Draft Annual Code Amendments (MC20-01)

Note: The proposed amendments are shown as red text that is either underlined or crossed out.

Figure 18.17.060-1 Exterior Facing Retaining Wall

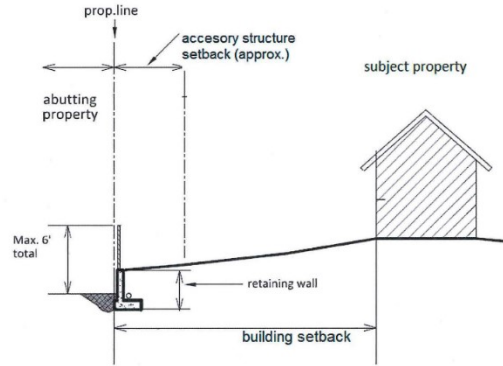
~~D.C.~~ [Exterior Facing Retaining Walls.] Exterior facing retaining walls are those walls that are supporting fill. The exposed side is facing the neighboring property or right-of-way and the fill side is within the subject property. (Refer to Figure 18.17.060-1 Exterior Facing Retaining Walls.)

1. When fence is atop the retaining wall, then the total height of wall and fence shall not exceed forty-two inches (front yard) or six feet zero inches (side and rear yards), or set back a distance of one foot for every foot in height of fence in excess of allowed height.
2. When retaining wall is over thirty inches above grade, then guards are required if on the property line.
3. If approved, retaining walls over six feet zero inches in height shall include landscaping to minimize bulky appearance, as approved by the Director. ~~will be subject to design review approval.~~

Figure 18.17.060-2 Interior Facing Retaining Wall

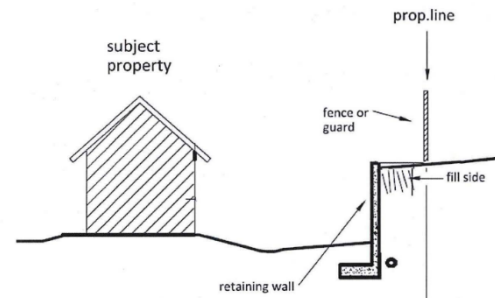
~~E.D.~~ [Interior Facing Retaining Walls.] Interior facing retaining walls are those walls that are supporting cuts. The fill side of the retaining wall is facing the neighboring property and the exposed side is facing the subject property. (Refer to Figure 18.17.060-2 Interior Facing Retaining Walls.)

1. When fence is atop the retaining wall, then the total height of fence shall not exceed forty-two inches (front) or six feet zero inches (side and rear) depending on location, unless fence meets setbacks.
2. When retaining wall is over thirty inches above grade, then guards are required if on the property line.
